Addendum #2 to the Technical Drainage Study for

AREA 15 DISTRICT 2

Date Prepared:
February 2023

28 OF 57 SHEETS
C03.15

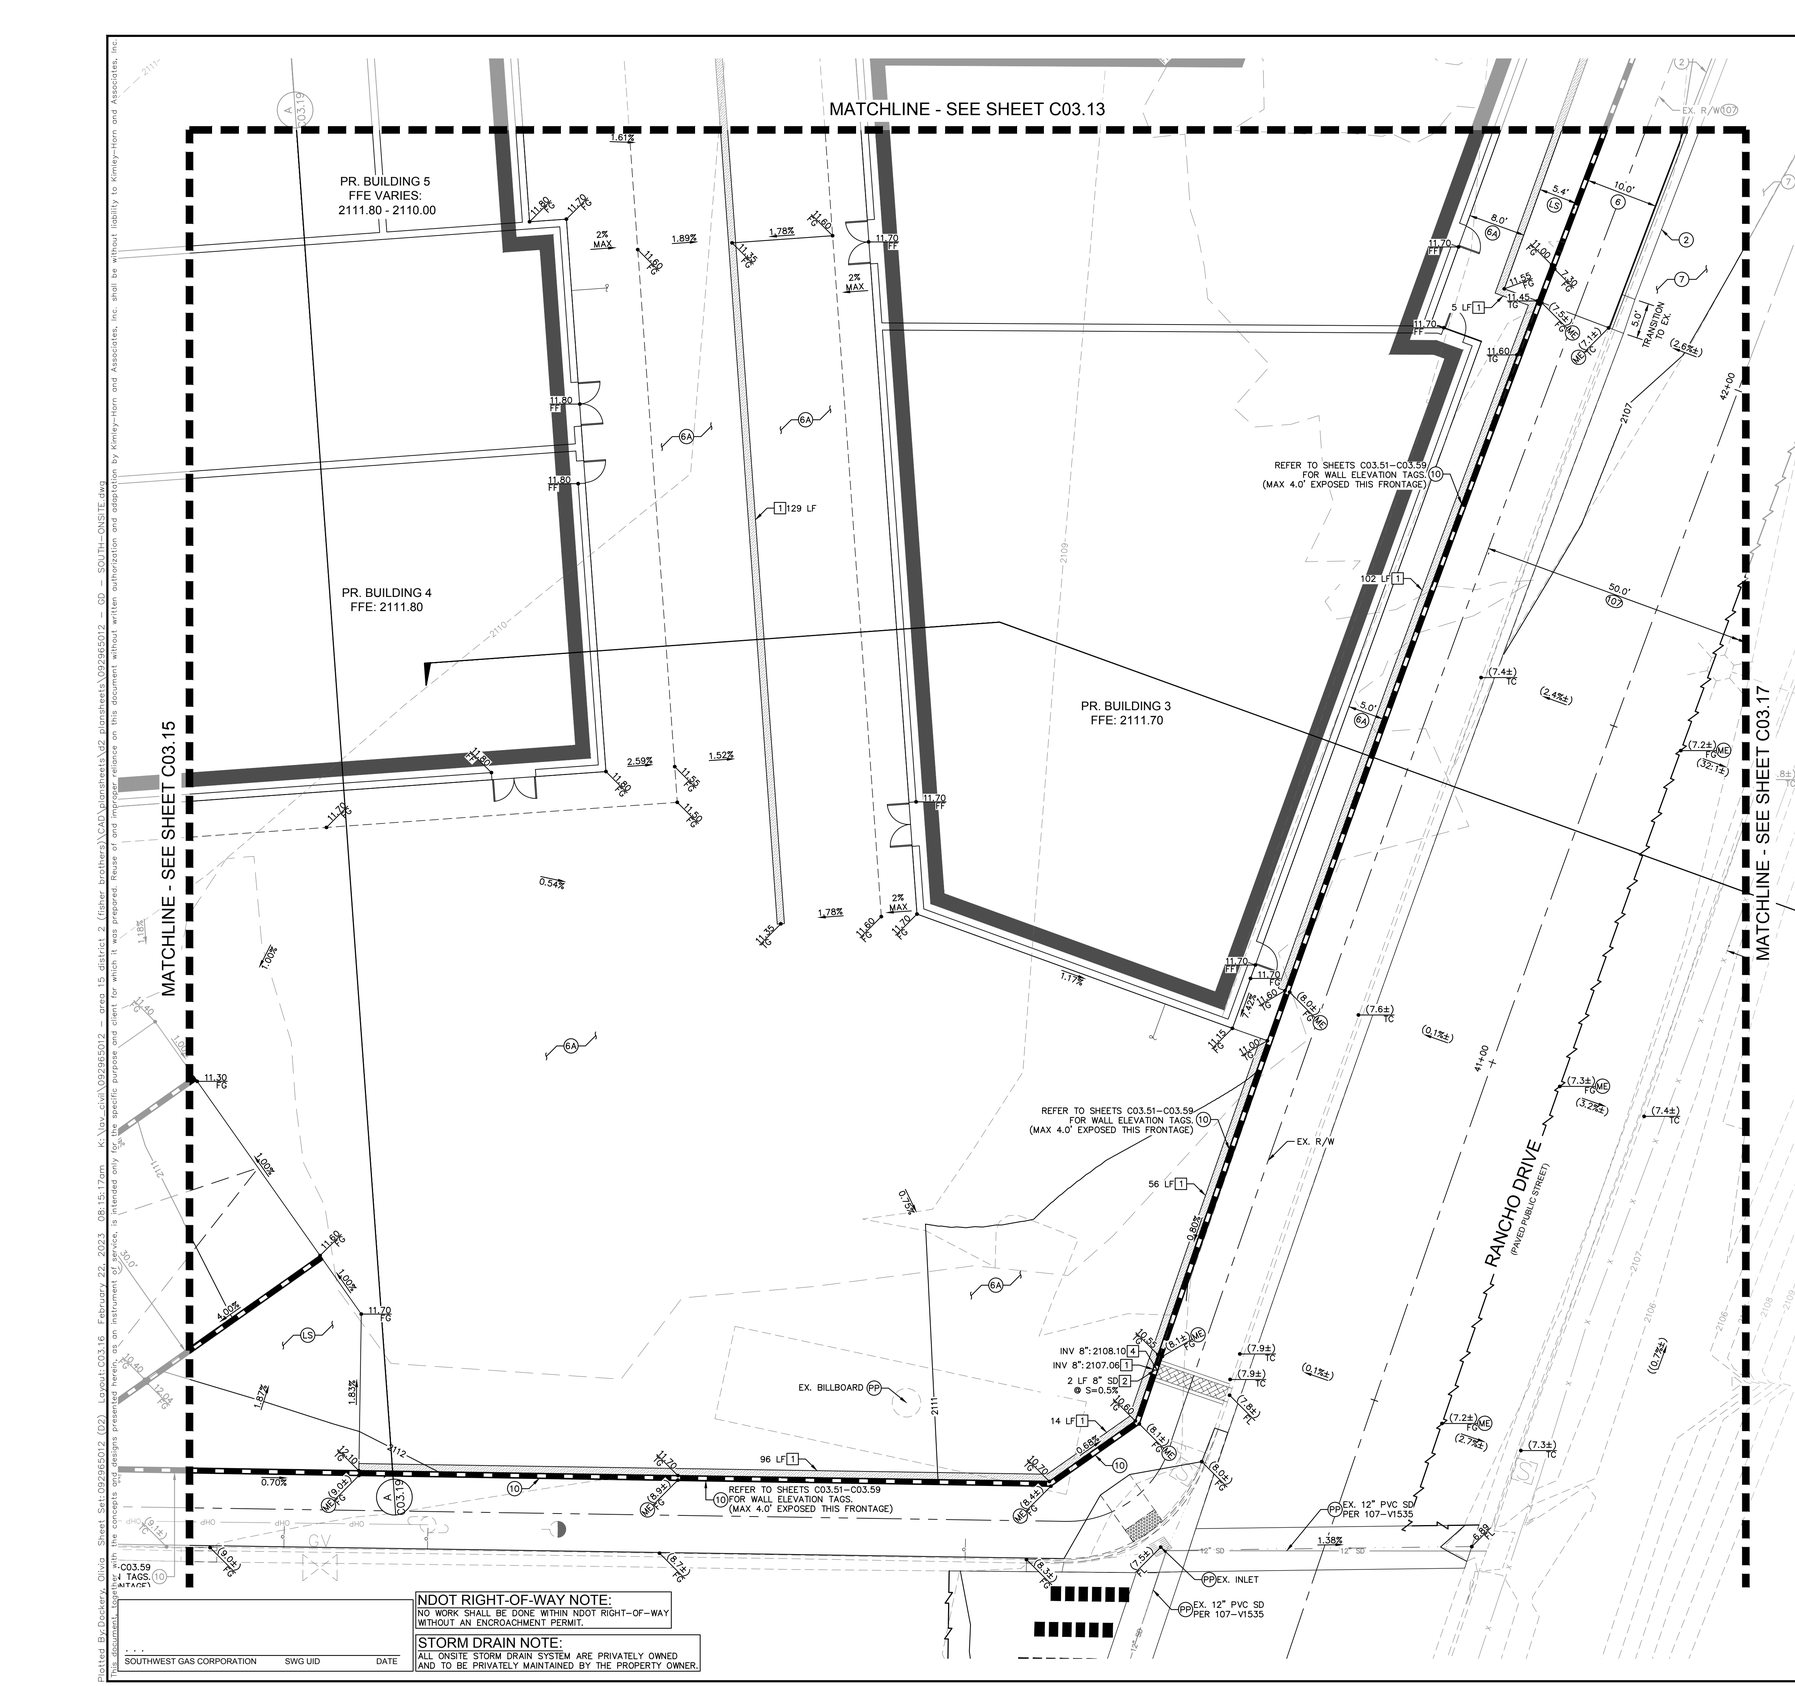
Comment 4: **Sheet C03.04, C03.05, & C03.15: Explain what will happen when the walls break for a ramp up to the buildings, what protection is offered for these buildings.**

Sheet C03.15: The proposed pedestrian access ramp at Sirius Avenue is elevated more than 6-inches above the WSE in the street (**HEC RAS Cross Section 1170**). Please refer to the improvement plans in **Appendix C**.

31 OF 57 SHEETS
C03.18

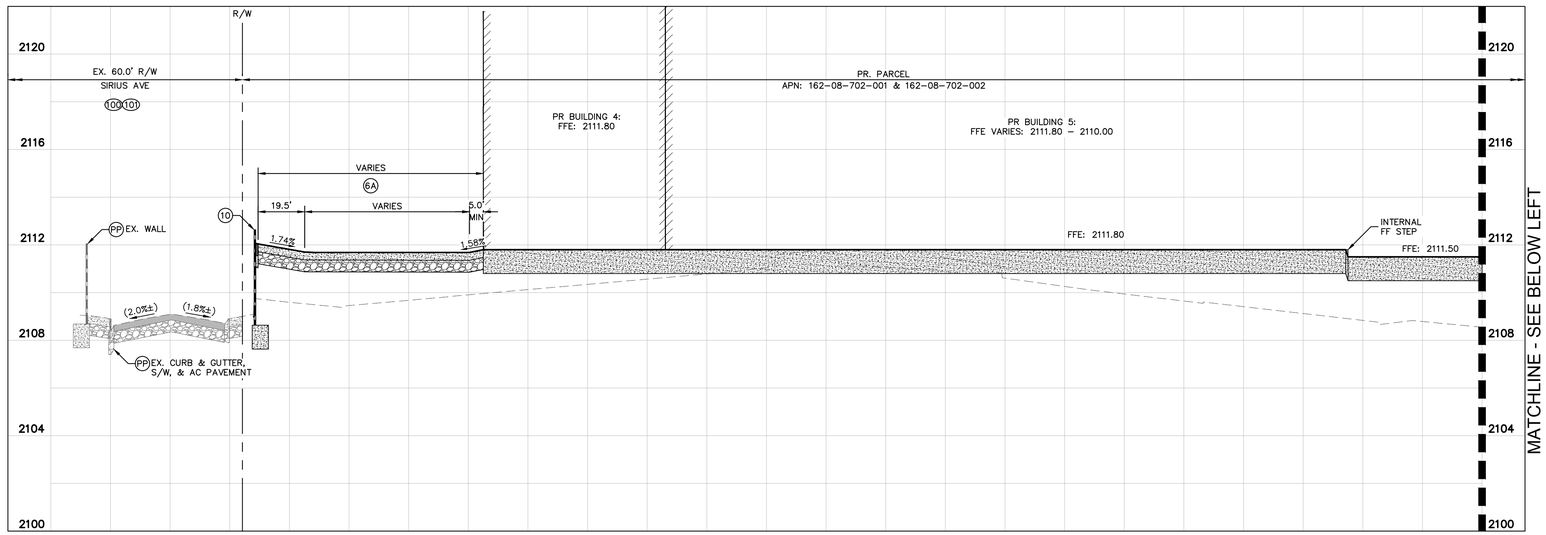
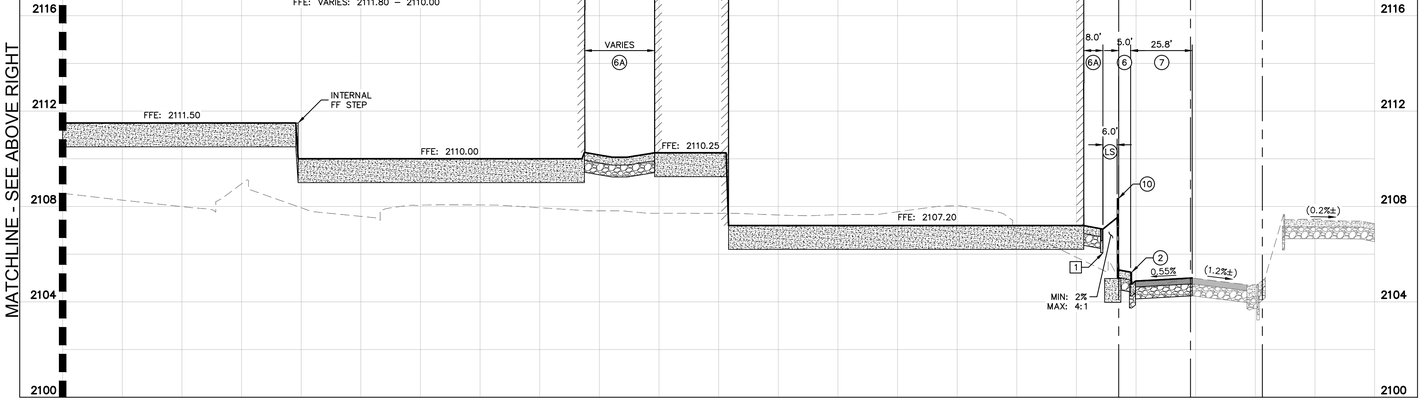
6. Provide contour labels and slopes for streets for sheets C03.51 – C03.56.
7. **Sheet C03.18**: ADA WALK DETAIL is overlayed on the parking garage. Remove the detail from the sheet.

Comment 7: **Sheet C03.18: ADA WALK DETAIL is overlayed on the parking garage. Remove the detail from the sheet.**

Response: As discussed in a meeting with CLV on February 13, 2023, the ADA Walk Detail will remain on **Sheet C03.18** to show the variable curb height.

K C03.00 SECTION K

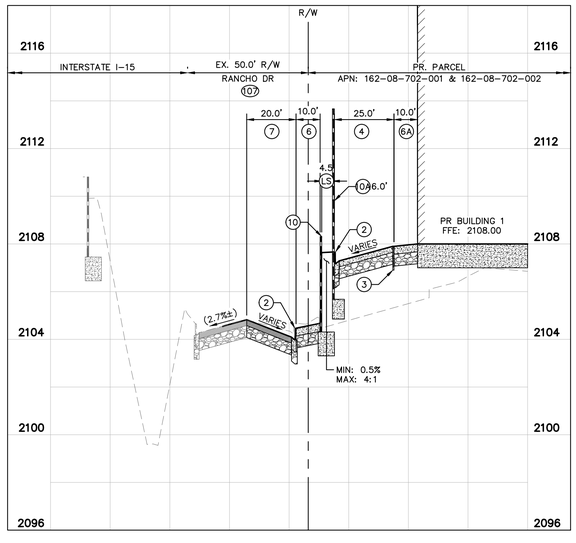
2. It is unclear what flood protection is provided. Construction Note 10 states solid grout 18" inches above finished floor. It also asserts a grouted screen wall with the screen height as noted on the grading plans. Clarify the situation with a section showing the solid grouting and provide a section at the high side of the PR Building 1 ensuring the finished floor is protected.
3. Provide missing contours on Sheet C03.10 (proposed) and C03.11 (existing).
4. **Sheet C03.04, C03.05, & C03.15:** Explain what will happen when the walls break for a ramp up to the buildings, what protection is offered for these buildings.

Response: As discussed in a meeting with CLV on February 13, 2023, **Section K/C03.21** has been revised to callout 6 feet of solid grouting (**Construction Note 10A**) for the proposed screen wall closest to Building 1 to provide finished floor protection for Building 1. The proposed solid grouting will provide a minimum of 18-inches of freeboard above the adjacent flow depth in Rancho Drive. Refer to the improvement plans in **Appendix C**.

49 OF 57 SHEETS
C03.51

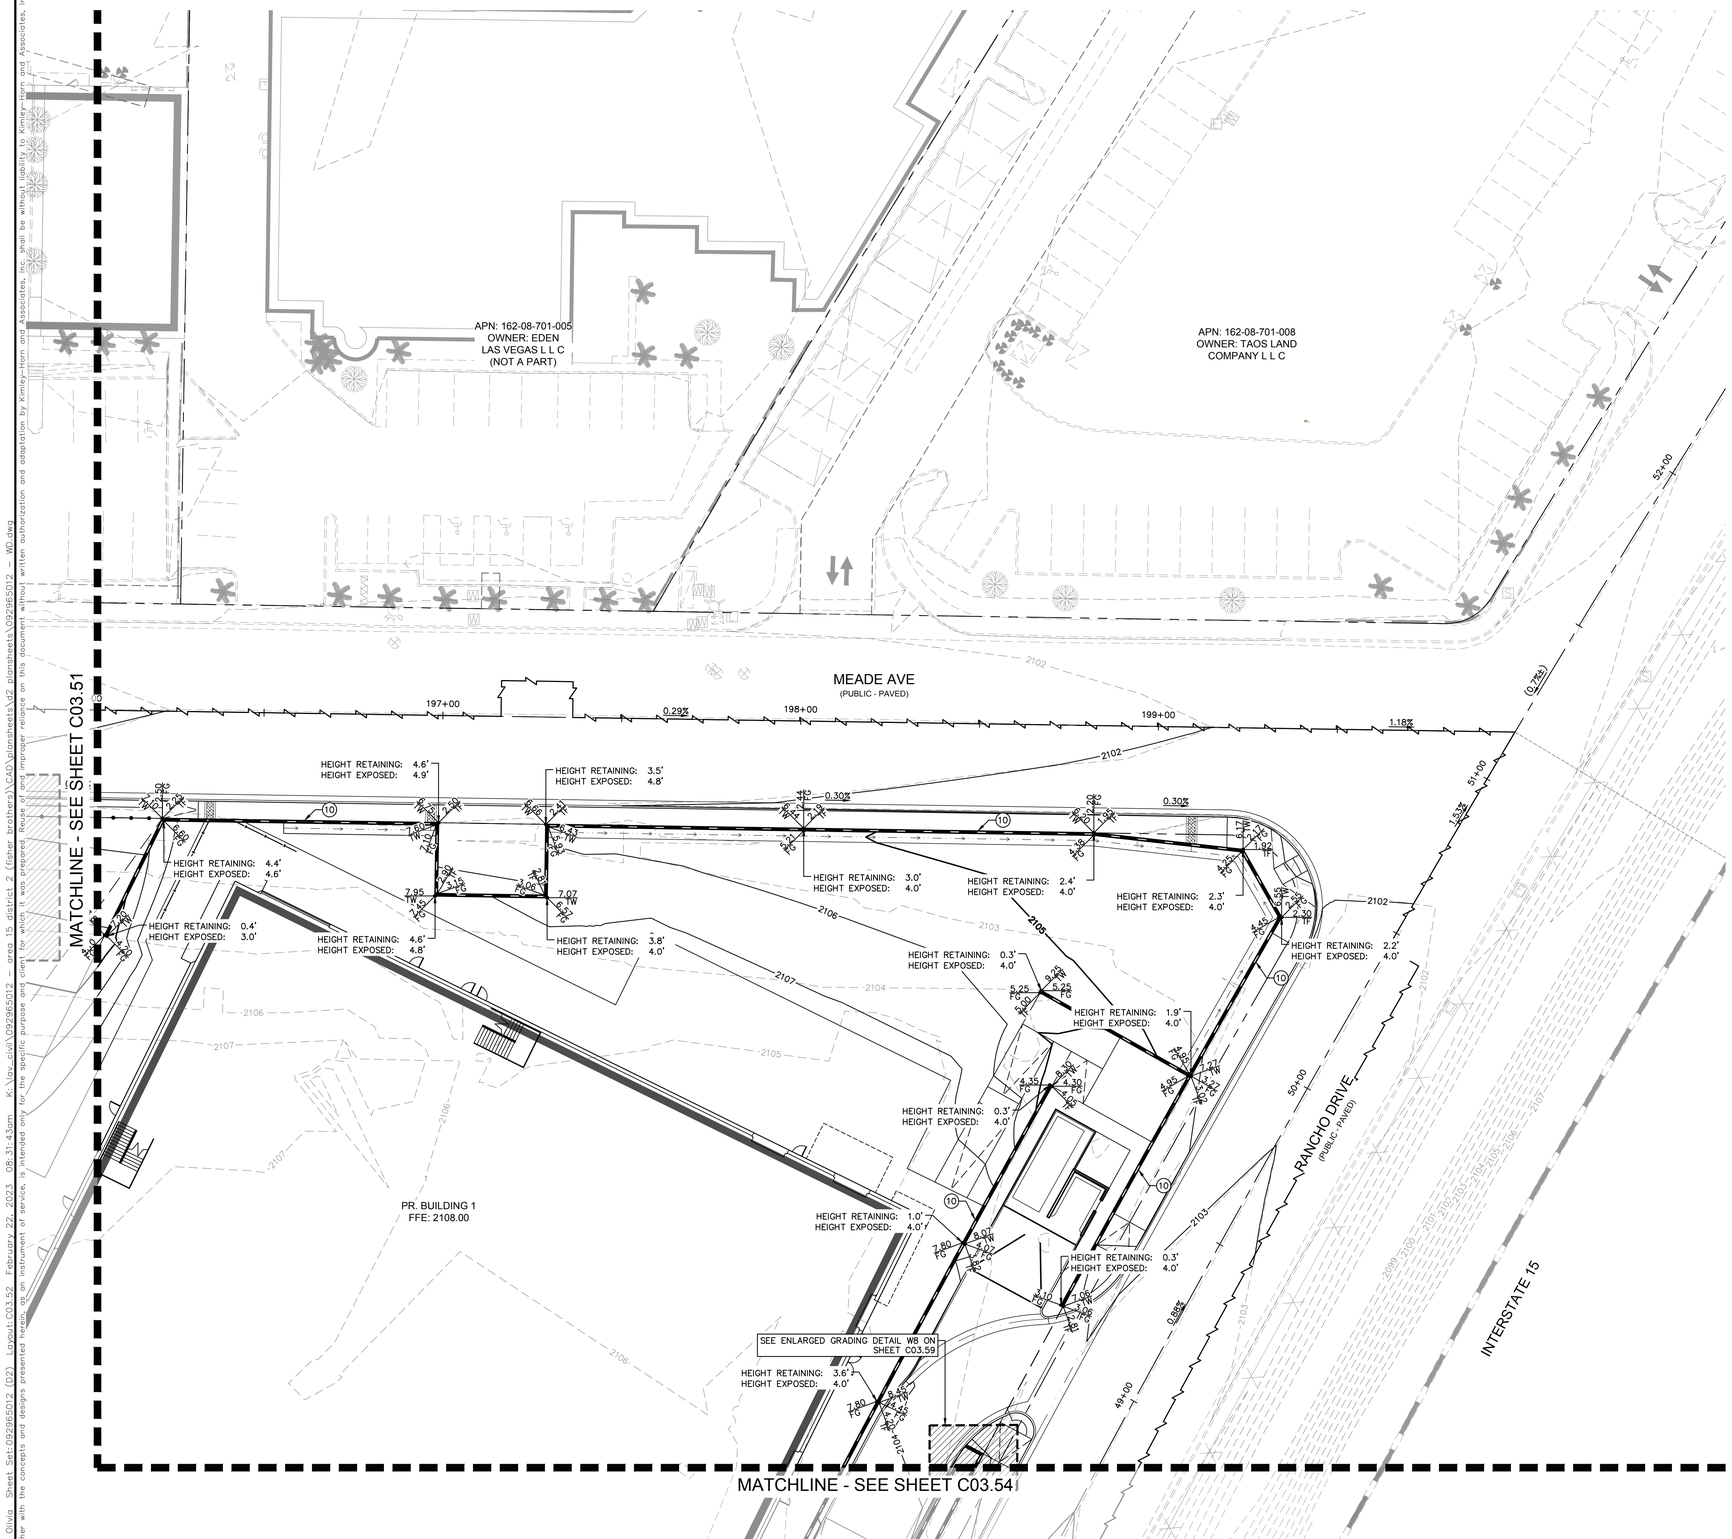
Comment 6: **Provide contour labels and slopes for sheets C03.51 – C03.56.**

Response: **Sheet C03.51** – **C03.56** have been revised to include contour labels and slopes. Refer to the improvement plans in **Appendix D**.
